Public Consultation
Submission Report
– 1st Non-Statutory
Public Consultation

BusConnects Dublin Core Bus Corridor Projects

Corridor 6 – Lucan to City Centre

Emerging Preferred Route – Public Consultation Report 2018/2019

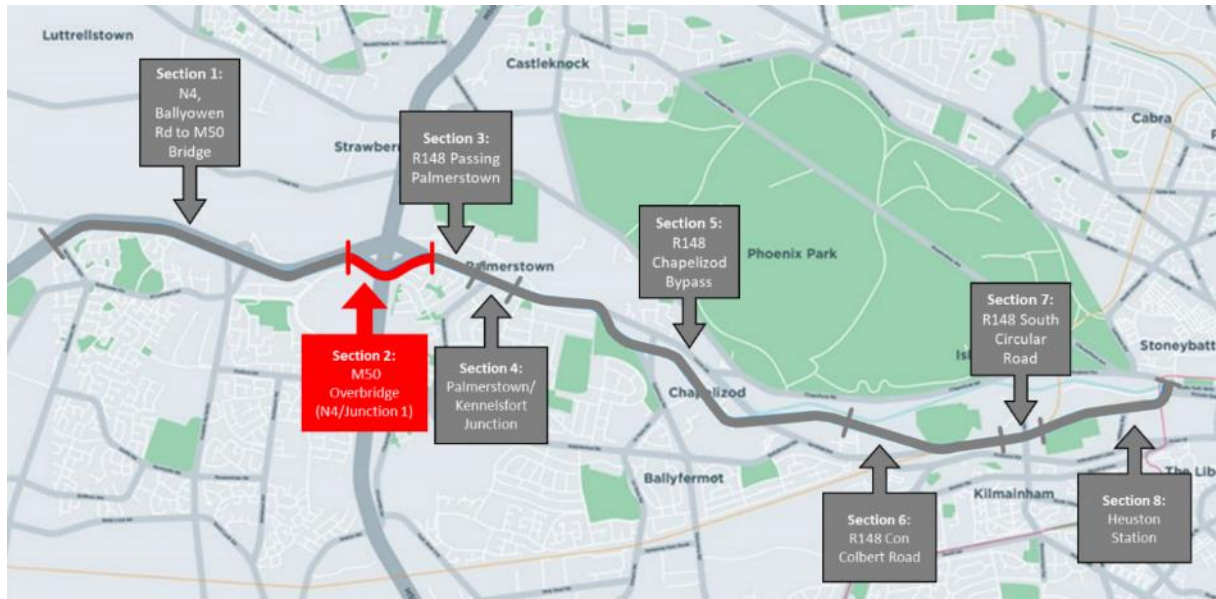
- Submissions highlighted that the Old Lucan Road carriageway was overly wide (8-12m), whereas the NCM sets maximum as 5.5 – 7m. Two solutions were offered:
 1. Narrow the carriageway to 5.5 – 6m to allow for wider footpaths and verge.
 2. Standardize the width to 8m and create 'Advisory Cycle Lane' as on page 58 of NCM.

Section 2: M50 Overbridge

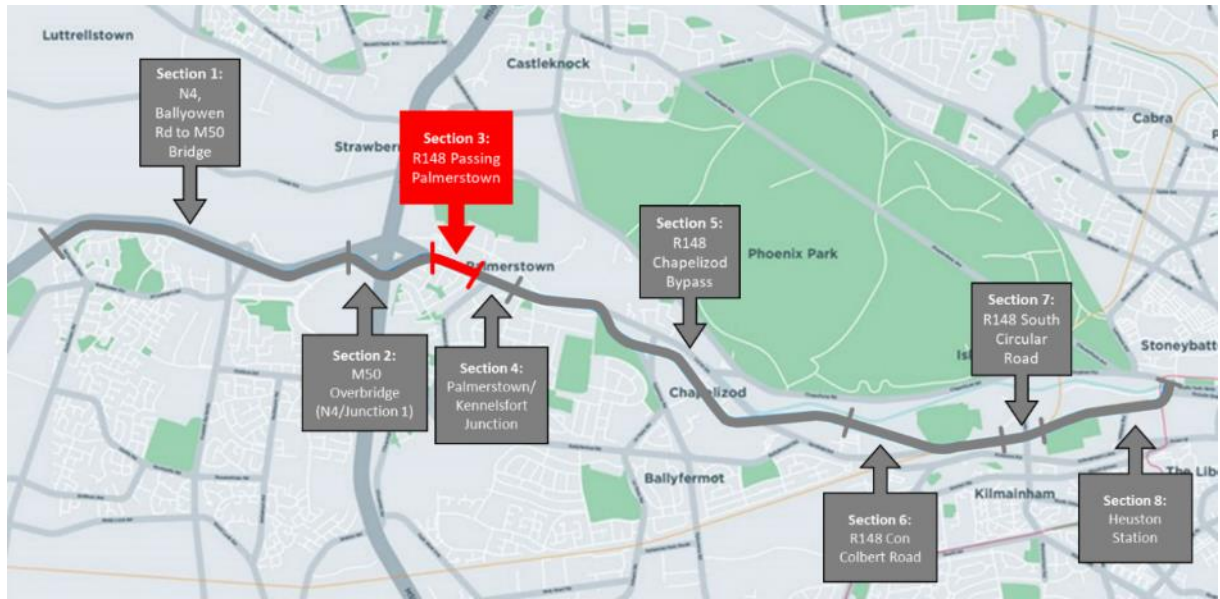
- Concerns were raised that the proposed reduction from 2 traffic lanes to 1 traffic lane on the M50 overpass to facilitate provision of a bus lane, in both the inbound and outbound direction, would have a serious impact on traffic congestion on the N4.

The lane allocation on the N4 eastbound crossing the M50 has been reviewed as part of the relocation further west of the bus stops serving the Liffey Valley shopping center. This results in an increased weaving length for N4 traffic heading towards the M50 North, the R148 to the city and the M50 South. While initial analysis suggests that the proposed arrangement is unlikely to have an adverse impact on traffic congestion, the lane allocation is the subject on-going more detailed traffic analysis to confirm this.

MAP 20:

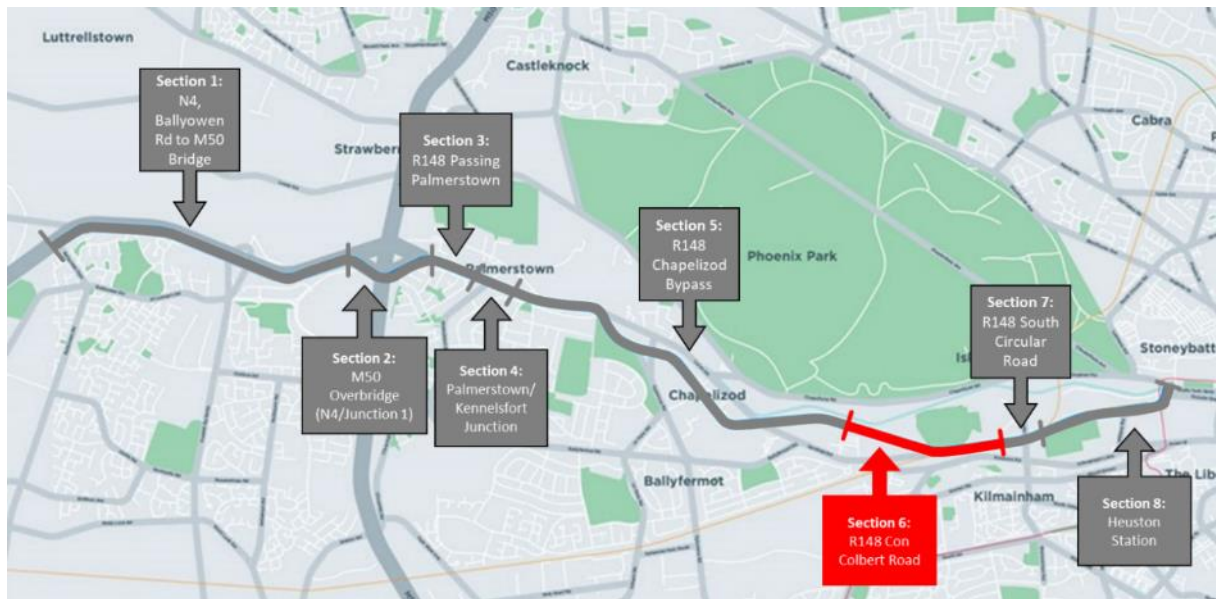
- Concern was expressed that the proposed footbridge on Chapelizod Hill Road would result in significant loss of greenery which would negatively impact the village and its character; the need for the new overbridge was questioned given that an underpass already exists.
- Concerns were also raised that the new bus stops / underpass/ overbridge was in a very secluded area; it was felt there was a need to provide adequate passive surveillance and lighting.
- It was also felt that the two proposed bus stops should be recessed, with concern expressed that having the stops in the bus lane could lead to accidents with buses and taxis leaving the bus lane to overtake other buses that were at the stop.

In relation to the queries raised about the proposals on Map 20 where the R148 Chapelizod Bypass crosses Chapelizod Hill Road, the proposal was not for a pedestrian overpass but for a signalized at-grade crossing of the R148 associated with proposed new bus stops. The arrangements at this location have been reviewed and modified to include steps and ramps which make use of the Chapelizod Hill Road underpass and avoid the need for an at-grade crossing of the R148.

The layout of the proposed bus stops on the Chapelizod Bypass at Chapelizod Hill Road has been reviewed. Revised ramp arrangements, steps and enhanced lighting are now proposed to address concerns raised about visibility and security. In addition a landscaping / urban realm scheme will be developed as part of the detailed design.
